PRODUCT / PROCESS CHANGE NOTIFICATION

PCN-000839

Date: JUN-08-2023

Change Details							
Part Number(s) Affected: Please see the next page for a list of affected part numbers.		Customer Part Number(s) Affected: ☒ N/A					
Description, Purpose and Effect of Change: DUAL SOURCING Semtech has qualified Greatek in Taiwan as a second assembly source for the affected part numbers listed on the following page. This change applies to 16MLPQ 4x4mm and 32MLPQ 5x5mm packages, currently assembled by UNSIEM(M) in Malaysia. Please see the following pages for comparisons on process flow, material, and equipment. Test platform and test programs are unchanged. <table border="1" data-bbox="318 1281 1334 1386"><thead><tr><th>Current assembly source</th><th>Secondary assembly source</th></tr></thead><tbody><tr><td>UNSIEM(M)</td><td>GREATEK</td></tr></tbody></table>				Current assembly source	Secondary assembly source	UNSIEM(M)	GREATEK
Current assembly source	Secondary assembly source						
UNSIEM(M)	GREATEK						
Change Classification	☐ Major ☒ Minor	Impact to Form, Fit, Function	☐ Yes ☒ No				
Impact to Data Sheet	☐ Yes ☒ No	New Revision or Date	☒ N/A				
Impact to Performance, Characteristics or

Comparisons

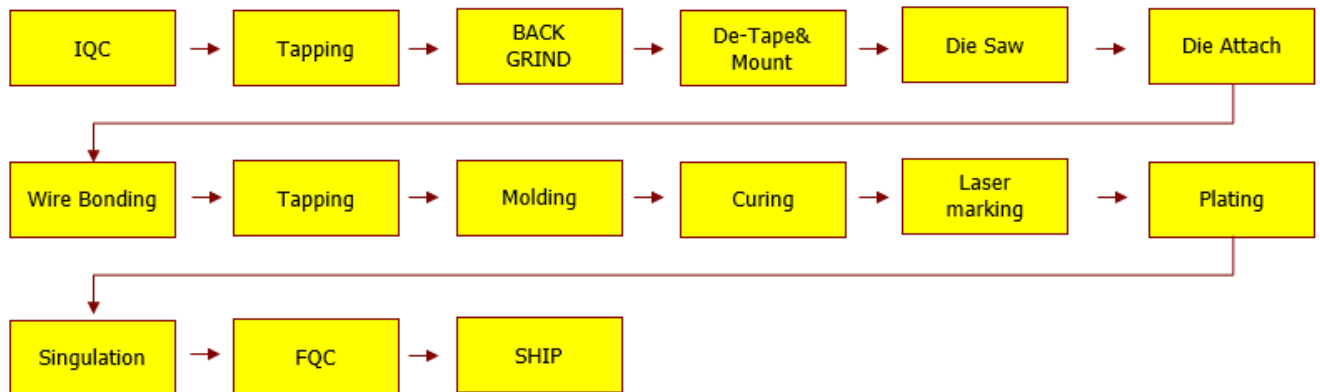
Material	UNSIEM(M)	GREATEK
Lead frame Material	Copper	Copper
Molding Compound	EMEG770HCD	Sumitomo G700H
D/A Epoxy	CRM1076NS	Sumitomo 1076DJ
Wire Material	Gold	Gold
